**EQUUS BEDS GROUNDWATER MANAGEMENT DISTRICT NO. 2
GROUNDWATER QUALITY PLANNING STATEMENT**

**CONCERNING
CASE NO. SUB 2002-18 – SECOND ADDITION TO BENTLEY FARMS**

STAFF REPORT
(PRELIMINARY PLAT)

CASE NUMBER: SUB 2002-18 -- SECOND ADDITION TO BENTLEY FARMS

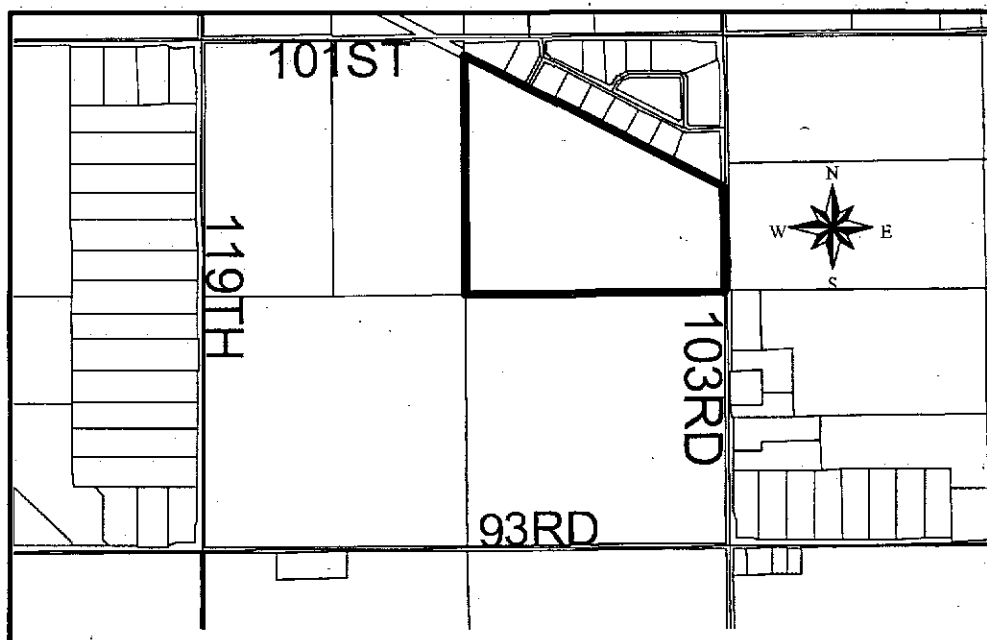
- A. This site is located within a half-mile radius of a City of Wichita Community wells. The applicant is advised that the City Water and Sewer Department has expressed concerns in the past regarding groundwater contamination from septic tanks in these areas.

- B. Since sanitary sewer is unavailable to serve this property, the applicant shall contact County Code Enforcement to find out what tests may be necessary and what standards are to be met for approval of on-site sewerage facilities. A memorandum shall be obtained specifying approval. ~~Due to the size of the platted lots, approval will be needed for the use of septic systems.~~
on-site

- D. County Engineering needs to comment on the status of the applicant's drainage concept. **The drainage concept needs to identify drainage outfall and demonstrate that adequate positive drainage can be achieved. A drainage concept and master lot grading plan is needed.**

- E. County Engineering needs to comment on the need for access controls along 103rd St. West. The final plat shall reference the dedication of access controls in the plat's text. **County Engineering has requested complete access control along the plat's frontage to 103rd St West except for one 40-ft joint access opening to lots 3 and 5, Block 1.**

- H. The lot numbers in each block should be revised to include consecutively numbered adjoining lots.
- I. In accordance with the Subdivision regulations for suburban subdivisions, the two turnarounds need to be increased to a 75-ft property line radius.

- K. Lots 5 and 6, Block 1, Lots 2 and 9, Block 2, and Lots 9 and 15, Block 3 do not conform with the 200-ft lot width standard which is measured at the building setback line. An increase in the distance of the building setback from the road would meet the standard.

- L. Lot 2, Block 2, and Lots 9 and 15, Block 3 do not meet the 100-ft lot frontage requirement.

- M. The County Fire Department/GIS needs to comment on the plat's street names. County Fire Department/GIS request a new street name for the east-west Chinook. GIS recommends "W 98th St N" and "W 98th Ct N" for the cul-de-sac.

SUB 2002-18 -- Revised Preliminary Plat of SECOND ADDITION TO BENTLEY FARMS
April 25, 2002 - Page 2

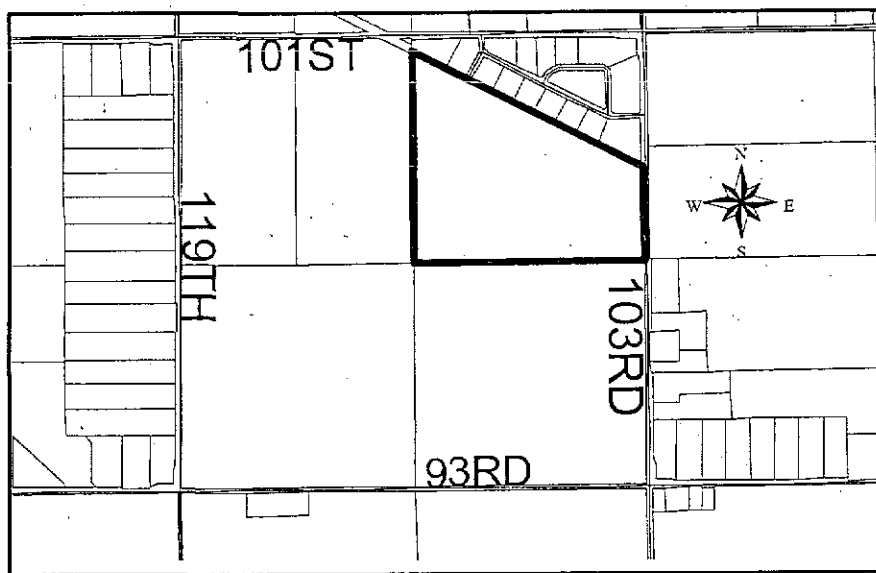
This revised plat has increased the minimum lot size to 4.5 acres, and revised the street layout. In lieu of septic systems, sewage lagoons are proposed.

- A. This site is located over the Equus Beds aquifer. The **Equus Beds Management District** is currently reviewing the proposed use of sewage lagoons for the site.

- E. **County Engineering** needs to comment on the status of the applicant's drainage concept. **The drainage concept needs to identify drainage outfall and demonstrate that adequate positive drainage can be achieved. A drainage concept and master lot grading plan is needed.**

- F. The final plat shall reference the dedication of access controls in the plat's text. The face of the plat shall indicate "complete access control" along Lot 7, Block 1 and Lot 14, Block 2.

- G. The applicant shall guarantee the installation of the proposed streets. The two Chinook Courts need to be built to 36 feet wide and 6 inches thick rock standard.

The requested contingent dedications of right-of-way have been provided. **County Engineering** requests that the contingent street dedication extending to the south be relocated to a point between Lots 11 & 12 of Block 2 and that the contingent street dedication extending to the west be relocated between Lots 5 & 6 of Block 2.
- I. The Applicant is advised that if platted, the building setbacks may be reduced to 35-ft from the section line roads and 30 feet from the interior streets.
- J. Lots 6, 7, 11 and 12, Block 2 do not conform with the 200-ft lot width standard which is measured at the building setback line. A modification by the Subdivision Committee will need to be approved.
- K. **County Fire Department/GIS** needs to comment on the street names.

SUB 2002-18 -- Revised Preliminary Plat of SECOND ADDITION TO BENTLEY FARMS
March 14, 2002 - Page 3

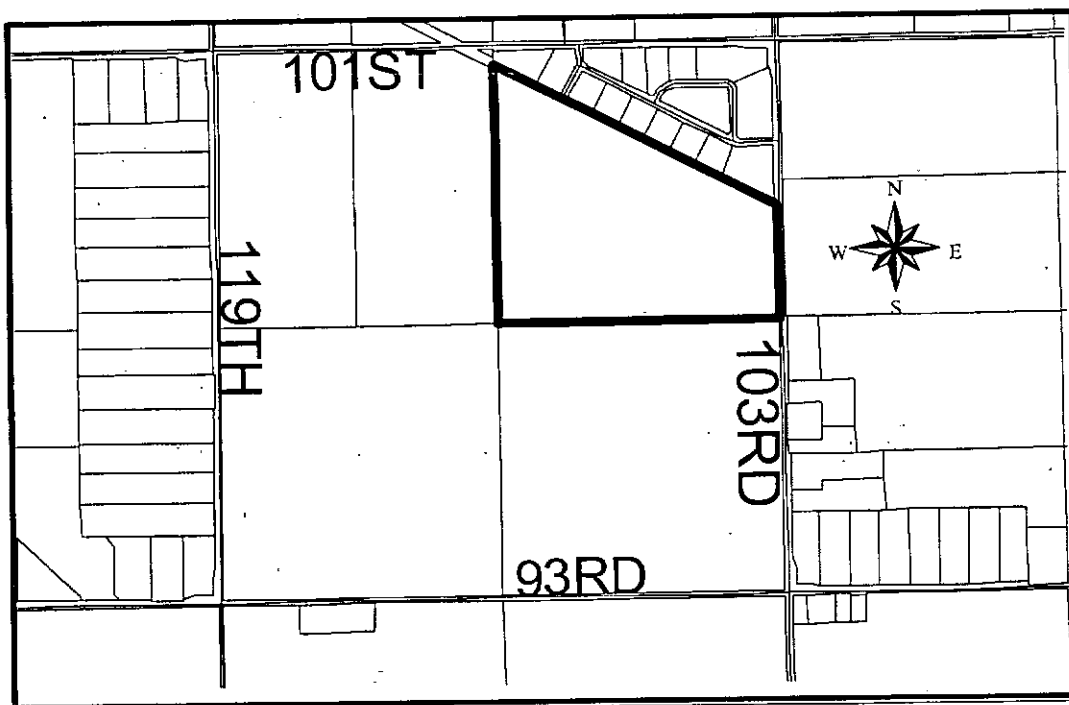
- A. This site is located over the Equus Beds aquifer. The Equus Beds Management District has recommended the prohibition of septic tanks for this property and the installation of a community waste treatment system.

- B. This site is located within a half-mile radius of a City of Wichita Community wells. City Water and Sewer Department and MAPD recommend the following:

- E. County Engineering needs to comment on the status of the applicant's drainage concept. ***The drainage concept needs to identify drainage outfall and demonstrate that adequate positive drainage can be achieved. A drainage concept and master lot grading plan is needed.***

- F. The final plat shall reference the dedication of access controls in the plat's text. ***County Engineering has requested complete access control along the plat's frontage to 103rd St West except for one 40-ft joint access opening to lots 3 and 5, Block 1.***

The applicant has proposed one 40-ft wide driveway located within a 70-ft joint access opening between Lots 3 and 5. The face of the plat shall indicate "complete access control" along appropriate segments of frontage along 103rd St. West.

- J. Lots 2, Block 2, and Lot 13, Block 3 does not conform with the 200-ft lot width standard which is measured at the building setback line. A modification by the Subdivision Committee will need to be approved.

- 1) No more than 20 buildable lots be created on the 100 acres, whatever the size of the individual lots;
 - 2) Sewage treatment shall be of an "alternative" type approved by County Public Works and Code Enforcement Offices;

- 3) The developer shall establish a groundwater monitoring system in advance of the development, develop baseline readings, and maintain the monitoring system for a period beyond the build-out of the addition.

- 4) The developer shall submit a financial guarantee, to be held for a period beyond the build-out of the addition, of an amount that is determined to be adequate to remediate groundwater pollution that may occur from operational failure of the sewerage system(s).

- 5) Water quality shall be tested by the developer prior to the approval of this plat to ensure that it is drinkable.
- C. Since sanitary sewer is unavailable to serve this property, the applicant shall contact County Code Enforcement to find out what tests may be necessary and what standards are to be met for approval of on-site sewerage facilities. A memorandum shall be obtained specifying approval.

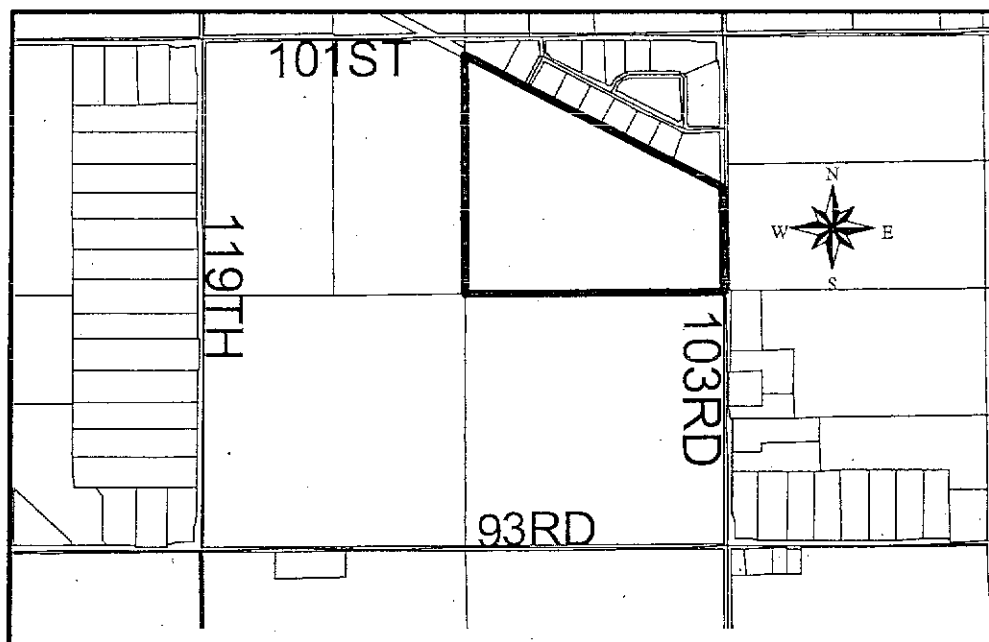
- A. This site is located over the Equus Beds aquifer. The Equus Beds Management District has approved the use of sewage lagoons for the site.
- B. Since sanitary sewer is unavailable to serve this property, the applicant shall contact **County Code Enforcement** to find out what tests may be necessary and what standards are to be met for approval of on-site sewerage facilities. A memorandum shall be obtained specifying approval. County Code Enforcement has approved the site for sewage lagoons.

- D. **County Engineering** needs to comment on the status of the applicant's drainage plan. The drainage plan has not been approved. An agreement with the property owner(s) to the west is needed verifying that they will continue to accept the water and not block the discharge.

- E. The applicant shall guarantee the installation of the proposed streets. The two Chinook Courts need to be built to 36 feet wide and 6 inches thick rock standard.

The Applicant is advised that although the streets are under construction, no street plans have been approved.
- F. On the final plat tracing, the contingent dedication of right-of-way needs to be referenced in the plat's text. The language should state that "the contingent street dedications are hereby contingently dedicated as street right-of-way to become effective upon the platting of any adjacent subdivision having a street connecting thereto. The costs of constructing said street, are to be borne by the person(s) or agency that owns said adjacent subdivision."

- H. Lots 6, 7, 11 and 12, Block 2 do not conform with the 200-ft lot width standard which is measured at the building setback line. The Subdivision Committee has approved a modification contingent upon each lot conforming with the 100-ft frontage requirement.

- I. **County Fire Department/GIS** needs to comment on the street names. The street names are approved.
- J. The maintenance responsibility of the drainage detention easements needs to be noted in plat's text.
